State of Ohio Environmental Protection Agency

Re: Lucas County
Arbors at Oregon
Construction
Storm Water

July 8, 2009

ArborsatOregon_060809_01
West side of entrance drive, looking west. Retention pond. Lower banks appeared to have been seeded. Houses south of pond are roofed and framed. Grading has been done and appears to be 2:1.

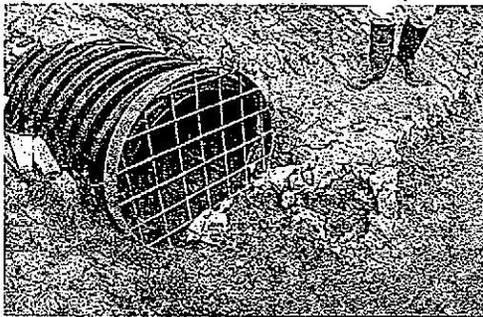
1. At the time of the inspection, the site was active. The units on the east side of the site were sided and roofed. Grass seed had been applied to the ground east of the drive and by these units. It had germinated. The units located west of the entrance drive and just south of the retention pond were framed and roofed. Utilities had been installed for at least the northeast portion of the development. Due to the absence of personnel or a construction trailer, the Storm Water Pollution Prevention Plans (SWP3) and inspection logs were not available for review.

ArborsatOregon_060809_03
Manhole after pond outlet. Appears to be riser pipe inside of manhole, with a 3-4 inch orifice on it.

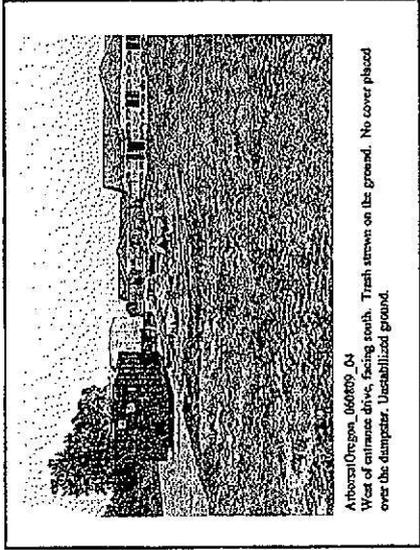
2. A large riser pipe located inside a manhole to the northeast of the pond appeared to form the outlet structure. An approximately 3 to 4 inch diameter orifice was evident on the riser pipe. The pond is required to meet the design requirements for a sediment settling pond until construction activities have ended and a perennial vegetative cover of 70% density has been achieved over the entire tributary area.

Without reviewing the SWP3, I am unable to determine if the pond meets the requirements of the permit. *Permit Requires:* Sediment settling ponds must meet the following criteria: a dewatering volume with a maximum depth of 5 ft., sized at 67 c.y. per drainage acre, and for drainage areas of 5 acres or more: a minimum 48 hour dewatering time; a sediment storage volume of 1000 c.f per disturbed acre provided below the dewatering zone; and at least a 2:1 length to width ratio between the nearest inlet and the outlet. *Please see Part III.G.2.d.ii. of the permit.* It will be necessary to modify the pond, if it does not already meet all of these requirements.

AlbionOregon_060809_04
West of entrance drive, facing south. Trash strewn on the ground. No cover placed over the dumpster. Unstabilized ground.

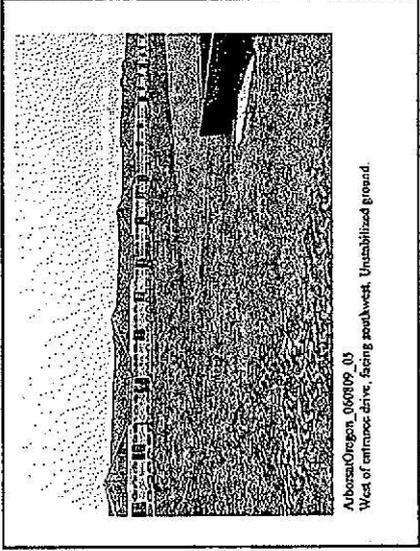
5. The dumpster to the east of the pond was uncovered, and trash and debris was present on the ground west of it. *Permit Requires.* No solid or liquid waste, including building materials, shall be discharged in storm water runoff. The permittee must implement all necessary BMPs to prevent the discharge of non-sediment pollutants to the drainage system of the site or surface waters of the State. *This is a violation of Part III.G.2.g.i. of the permit.*

AlbionOregon_060809_06
West of entrance drive, facing west-southwest. Inlet protection is disrepair around the manhole.

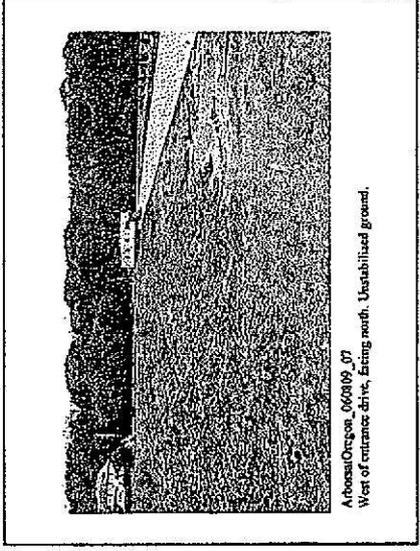
3. Inlet protection was present on the yard drains on the north end of the site. However, the structure around the outlet manhole was in disrepair, with the fabric missing on one side. The silt fence on the east side of the site was installed, but there were some sections of the fence that had been knocked down or torn. *Permit Requires:* All control practices shall be maintained and repaired as needed to assure continued performance of their intended function. *This is a violation of Part III.G.2.h. of the permit.* For more information on the correct installation and maintenance techniques for these practices, please see the *Rainwater and Land Development Manual*.
